| marantz® SERVICE BULLETIN | | Date: 15-May.-2003 | Model: DR6000, DR6050, CDR631, CDR500 |
| Circulation: | Application: | Subject: Replace the Chip capacitor on the CDR module of MAR770/MAR775. | |

| marantz® SERVICE BULLETIN | | Date: 22-Nov-01 | Model: DR4050/DR6000/DR605 0CDR500/CDR631 |

| | | Subject: Miss clamp problem of CD single | |

This is Pos.No.3114

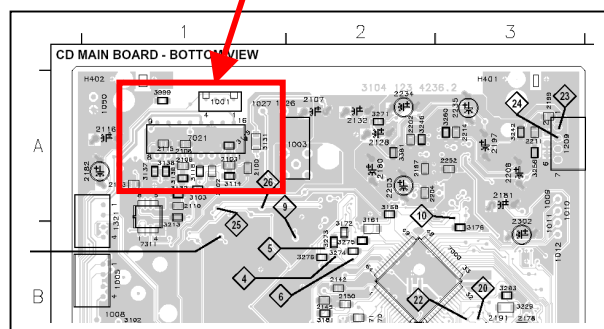
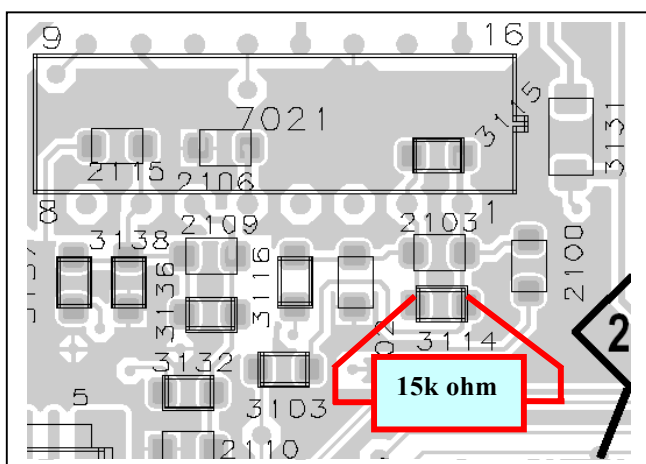
The OPEN/CLOSE movement of disc tray is fast, It may become a CD single [8cm(3in.)] clamp defect.

15k ohm resistor is soldered to the **Pos.No.3114** in parallel.

The object of PCB: CD MAIN BOARD of CD Module MAR1250
(Refer to the CDR500 service manual 2-13 page of MAR1250.)
